# Access Compliance Report

## Public Rights-of-Way

### (Pedestrian Signals)

Intersection ID: N/A	Main Street:	Cross Street: N/A	Location: N/A
ADA ID: 94670A7145B2	Signal Type: One Push Button-Non APS	Overall Compliance: No	Severity Score: BTN 1: N/A BTN 2: N/A No BTN: N/A
Codes/Mitigation Info/Possible Solution		Field Measurements/Component Compliance

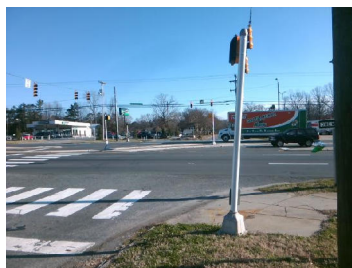
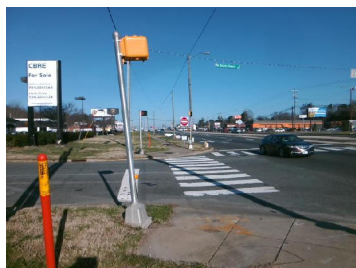
PROW/ADA: TMUTCD 4e.08, R404.2, R404.3, R406.2

Possible Solutions: Replace Signal Push Button With APS Button on New Post. Remove & Relocate Sign.
